UNIVERSITY OF WISCONSIN
NUCLEAR REACTOR
LICENSE NO. R-74
DOCKET NO. 50-156

LICENSE RENEWAL APPLICATION
SAFETY ANALYSIS REPORT,
AND
TECHNICAL SPECIFICATIONS
REVISION 2

Subject: License Renewal of the University of Wisconsin Nuclear
Reactor; License R-74, Docket 50-156

The changes described in the attachment are indicated by a vertical line in the margin of the enclosed revision 2 to the Safety Analysis Report for Renewal of License R-74 for the University of Wisconsin Nuclear Reactor, dated September 2008.

Figure 5-2 Pool Water Systems

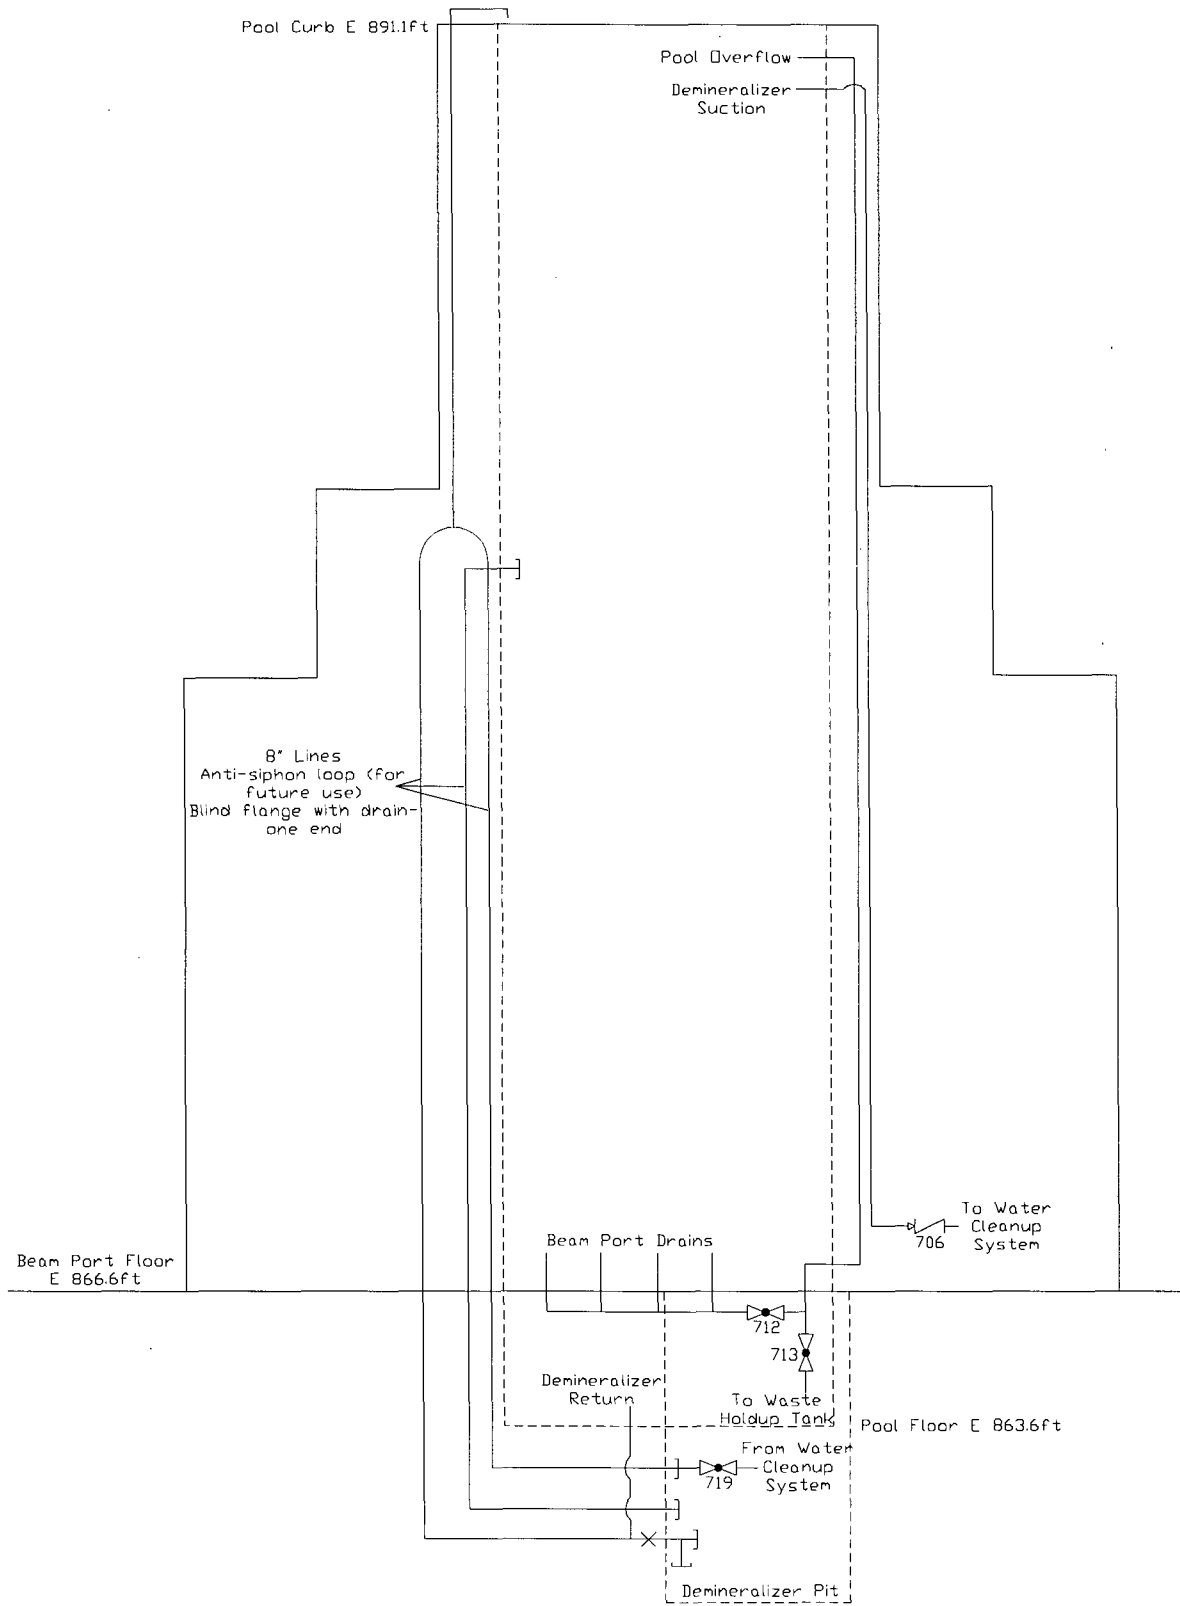
5.5	5-3,4	Updated flow rate and valve numbers for new demineralizer (18 gpm, valve 10102 service out, valve 22).	
Figure 5-2	5-5	Added new pool water systems schematic.	
Figure 5-3	5-6	Added new water cleanup system schematic.	
Figure 5-4	5-7	Added new water waste system schematic.	
Figure 5-5	5-8	Added new water makeup system schematic.	
Chapter 6

Figure 7-1 Instrumentation and Control Block Diagram

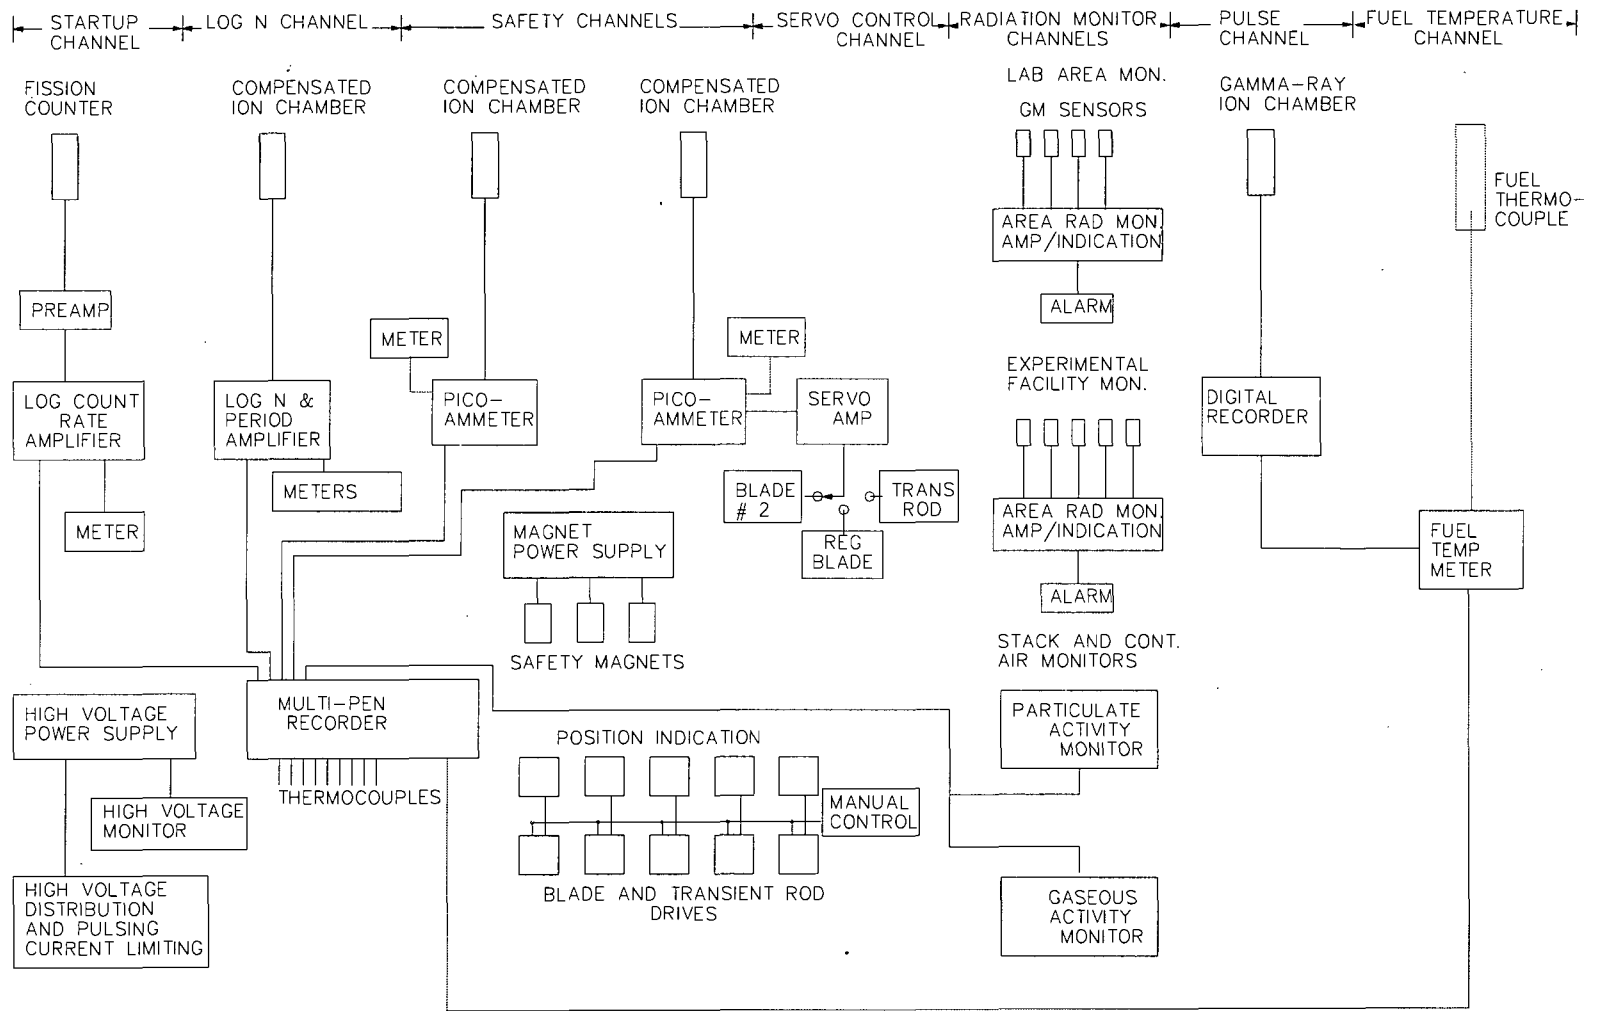
Section	Rev2 Page	Change	Reference
Figure 6-6	6-8	Updated diagram of lab facing west.	
Chapter 7			
7.1	7-1	Updated to include digital fuel temp, computer pulse, all digital recorder.	
Figure 7-1	7-2	Updated figure to reflect console upgrade.	RSC 773 ⁽²⁾ RSC 803 ⁽³⁾ RSC 887 ⁽⁴⁾

Figure 7-2 Scram Logic Elementary Diagram

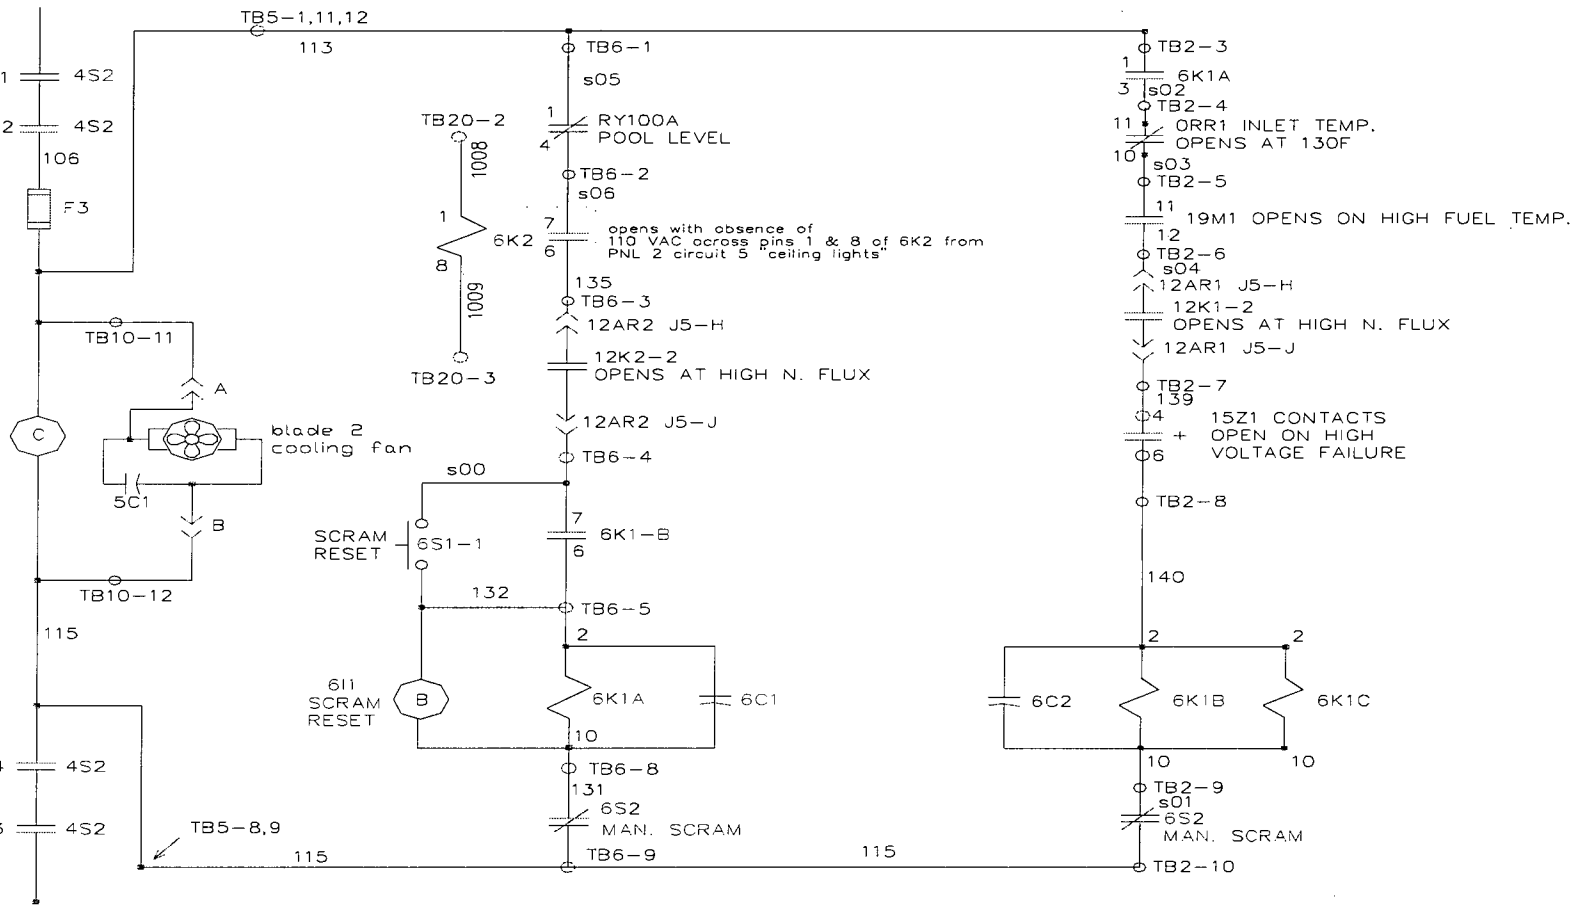
7.4	7-10	Removed reference to LogN not in operate scram which was removed.	RSC 887 ⁽⁴⁾
7.4	7-10	Clarified that pool level alarm is on high or low.	
Figure 7-2	7-11	Updated per console upgrade.	RSC 887 ⁽⁴⁾
Figure 7-3	7-12	Updated per console upgrade.	RSC 887 ⁽⁴⁾

Figure 14-1 Organization Chart

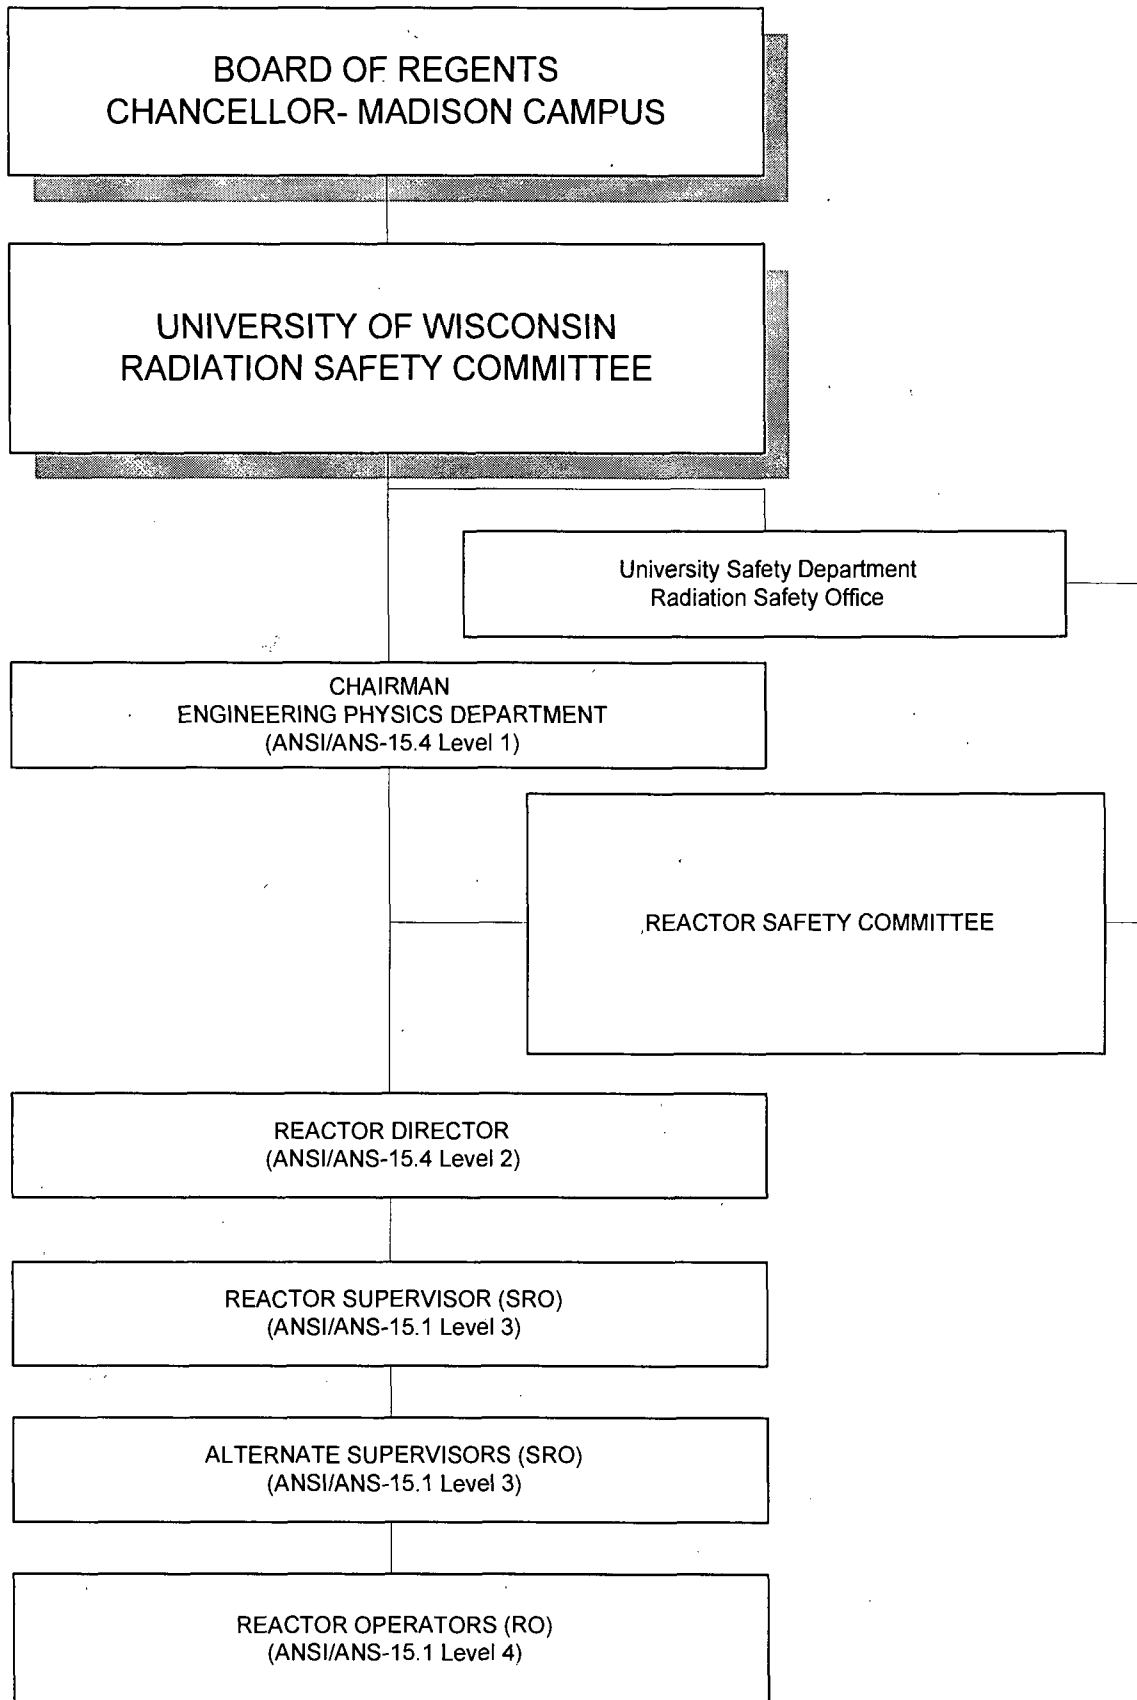
5.3	14-42	Revised outline numbering for consistency.	
6.1.1	14-45	Added reference to new Figure 14-1 (just copy of Figure 12-1).	
6.1.2	14-45	Fixed gender language.	
Figure 14-1	14-46	Added new figure for clarification (copy of Figure 12-1).
